Department of
Environmental Quality

DIVISION OF RADIATION CONTROL
Dane L. Finerfrock
Director

SUBJECT: July 29, 2008 DRC Letter Regarding White Mesa Uranium Mill Cell 4A Operation; July 31, 2008 DUSA Email Regarding 252 Photos on C.D. (received August 1, 2008), Showing Work Completed on Cell 4A Sand Bag Placement; August 7, 2008 DRC Email, Subject: Sandbag Adjustments (Partial Response to Submitted C.D. Photographs). **Request for Information**

SECTION
SLIMES DRAIN HEADER
SCALE: 1" = 1'

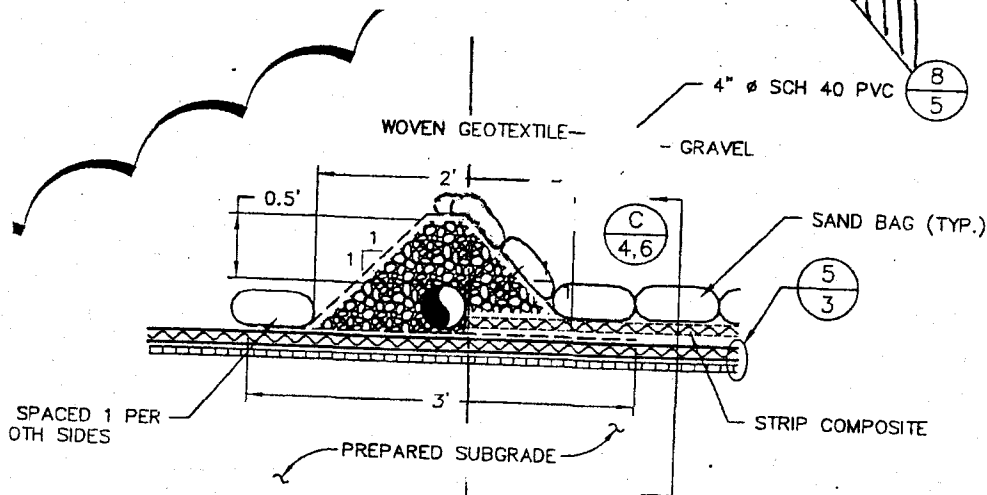
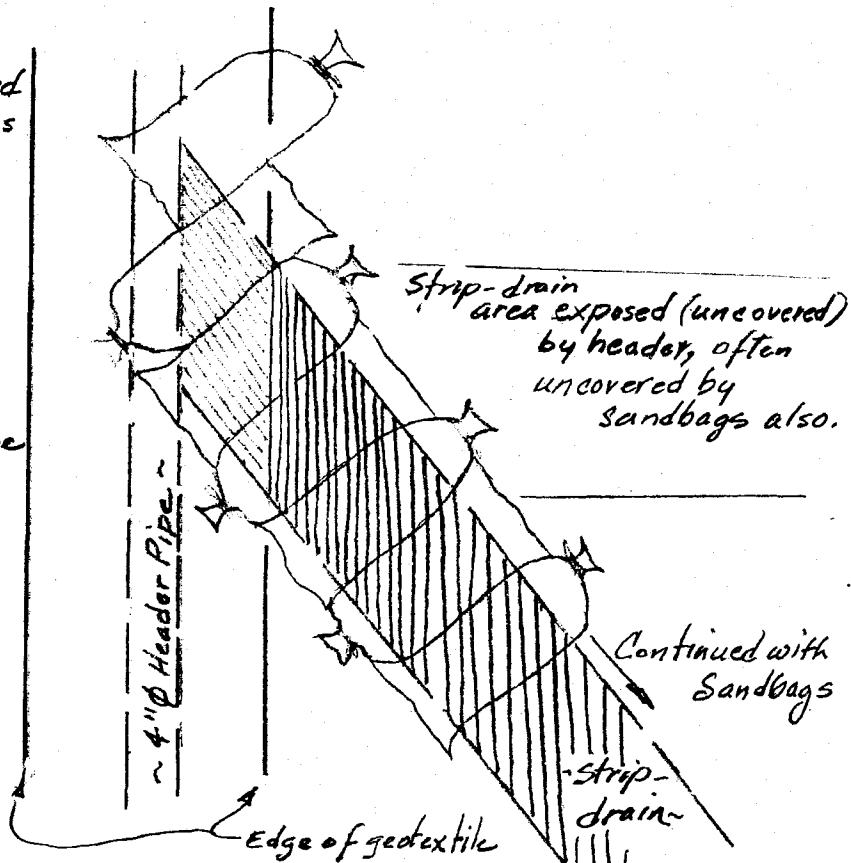
4. Not enough bags on the slimes drain header, to cover the projected strip-drain areas as provided in the DRC letter of July 29, 2008 with the attached DRC drawing dated July 25, 2008. E.g. see picture 1262.

strip-drain
Area currently to be covered
by sandbags for filter as
req'd by specs.

strip-drain area
to be covered by sand-
bags and header envelope
